SAMSUNG CD-RW
LED BOOM BOX
APPLICATION
CIRCUIT

Revised Version 1.0
Date : 2001.08.28

KYSHO
V12RW01 CDRW SAMSUNG LED DISPLAY
CHANGED 2002.07.30(SOLVE THE CD SIGNAL PLAY NOISE)

CONTROL BOARD

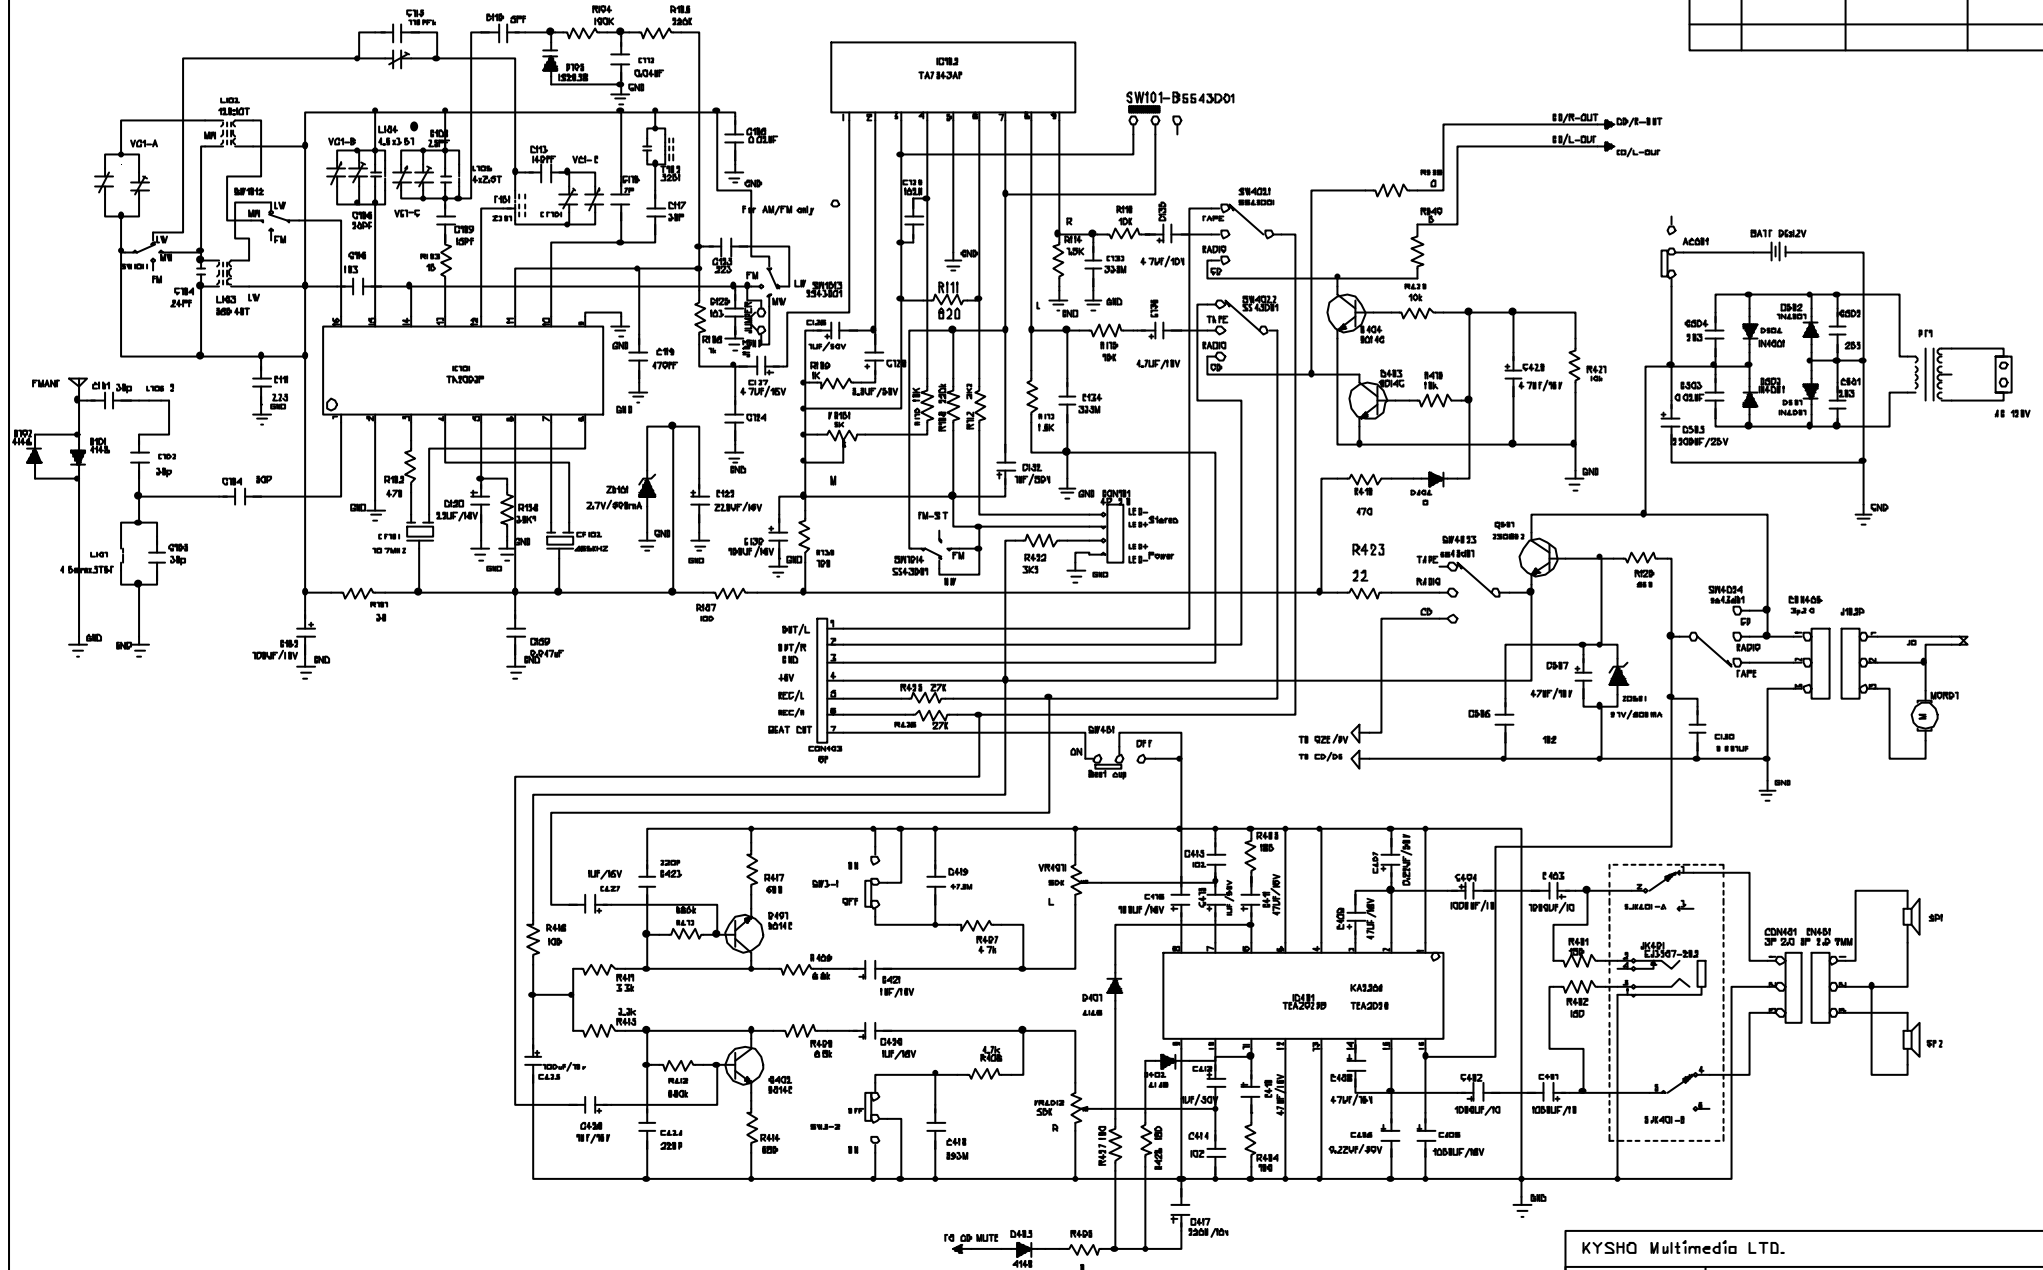
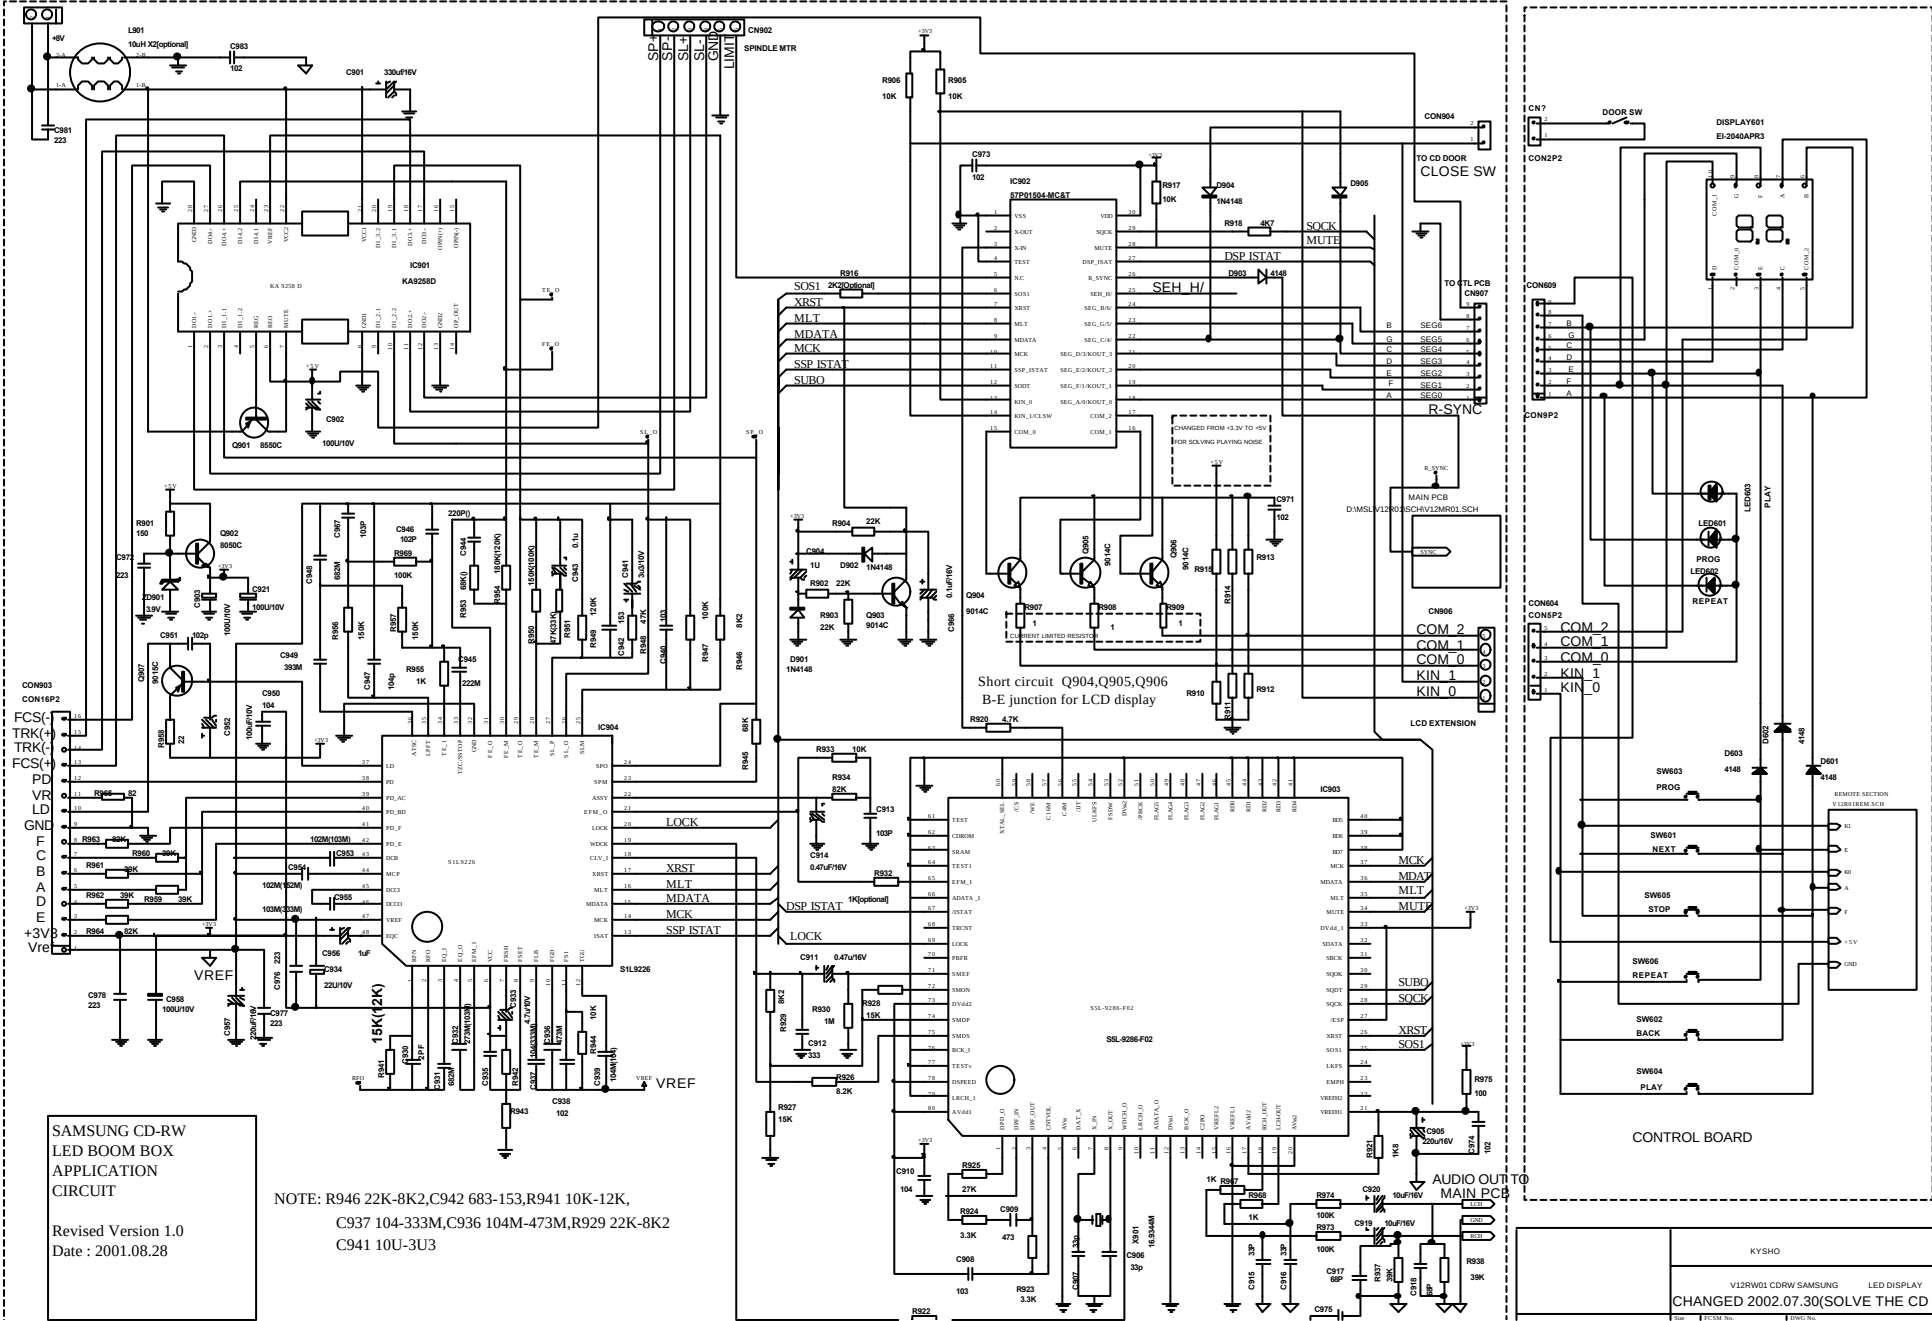
NOTE: R946 22K-8K2, C942 683-153, R941 10K-12K,
C937 104-333M, C936 104M-473M, R929 22K-8K2
C941 10U-3U3
